PENRITH CITY COUNCIL

MAJOR ASSESSMENT REPORT

Application number:	DA19/0172
Proposed development:	Demolition of Existing Structures & construction of a Two (2) Storey Boarding House containing 19 Boarding Rooms & Basement Car Parking
Property address:	12 Anthony Crescent, KINGSWOOD NSW 2747
Property description:	Lot 67 DP 212261
Date received:	7 March 2019
Assessing officer	Gemma Bennett
Zoning:	Zone R3 Medium Density Residential - LEP 2010
Class of building:	Class 3 , Class 7a
Recommendations:	Refuse

Drawing Sheet:
Shadows Plan
Scale: 1-500@A3

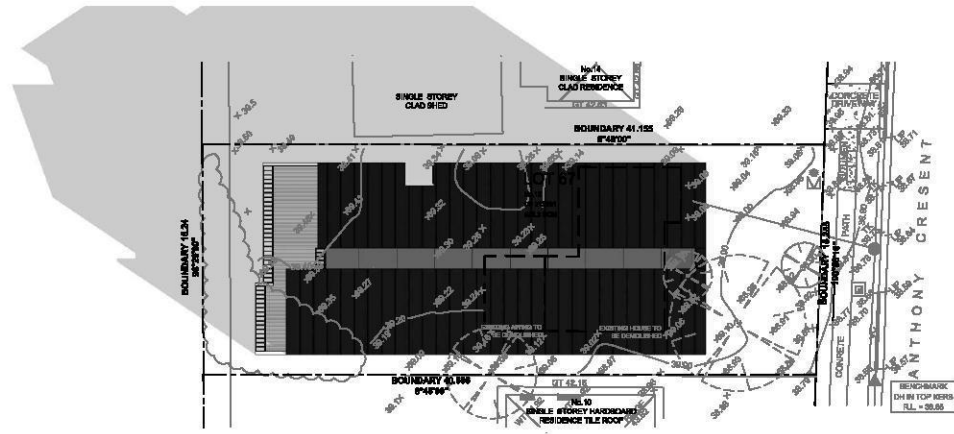
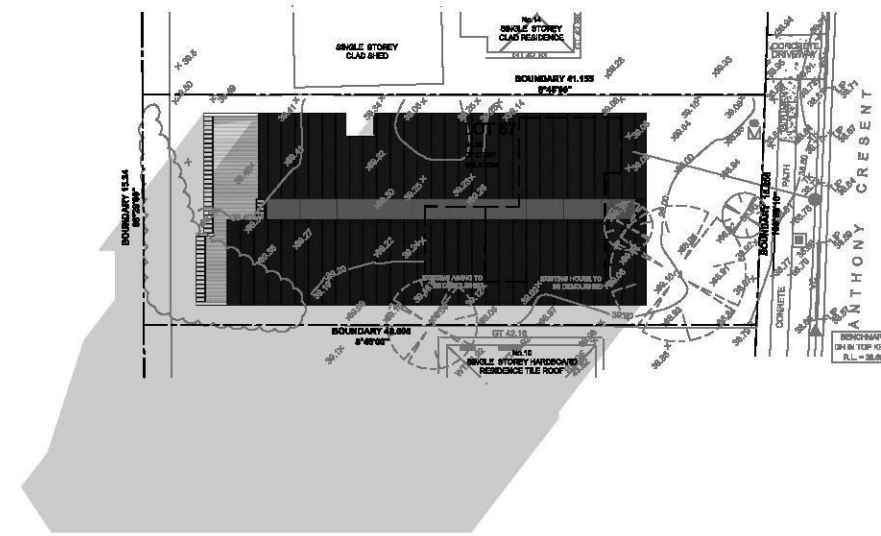
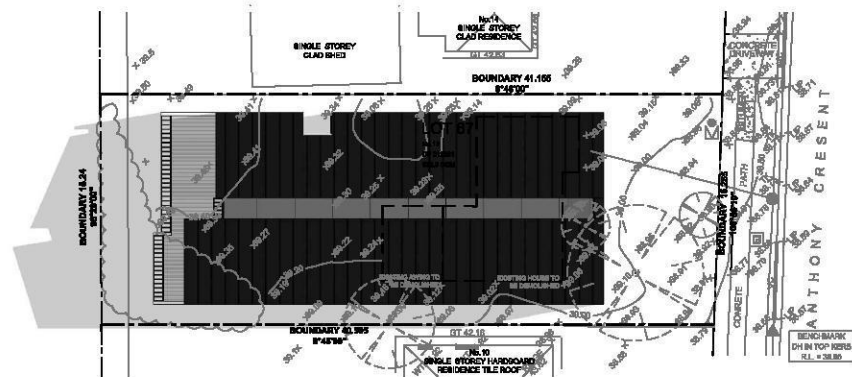
It is unclear from the plans submitted that solar access can be provided to the proposed common living room in accordance with the requirement of the SEPP ARH; being 3 hours of direct solar access between 9am and 3pm in mid-winter. There is little opportunity provided for natural cross flow ventilation or canopy trees on the site.

Project: Boarding House Development Lot 67, 12 Anthony Crescent, Kingswood Dp 212261	North:
Drawing Sheet: Colour + Material Schedule Date: 31.01.19	Drawing No: DA15 Revision: D

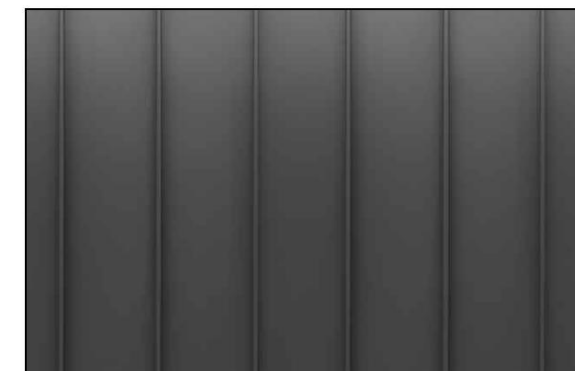
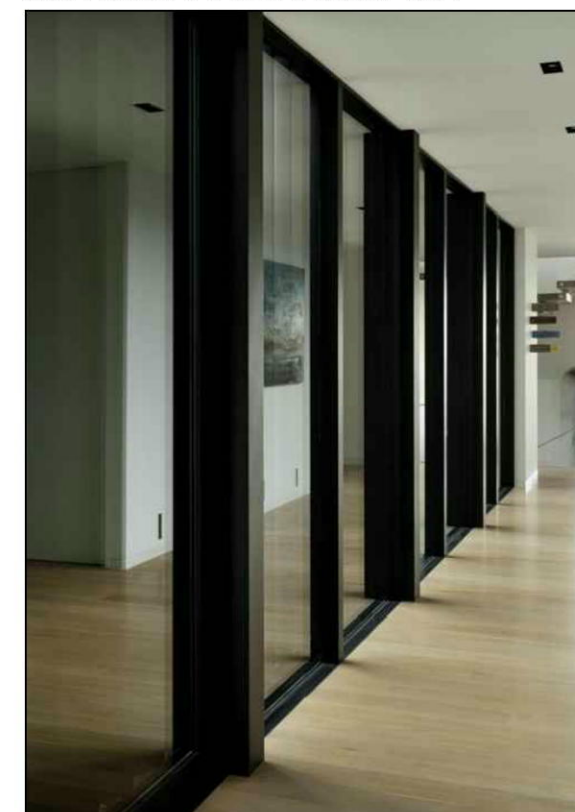
- *The external colour schedule, and other external plans, indicate that all surfaces on the first floor and roof will be black in colour. In the interest of incorporating principles from the 'Cooling the City Strategy 2016', lighter coloured materials would have a better outcome for the proposal and site. The increased solar reflectance of light shades would also contribute to the overall reduction of the urban heat island effect that is experienced in the Penrith Local Government Area.*
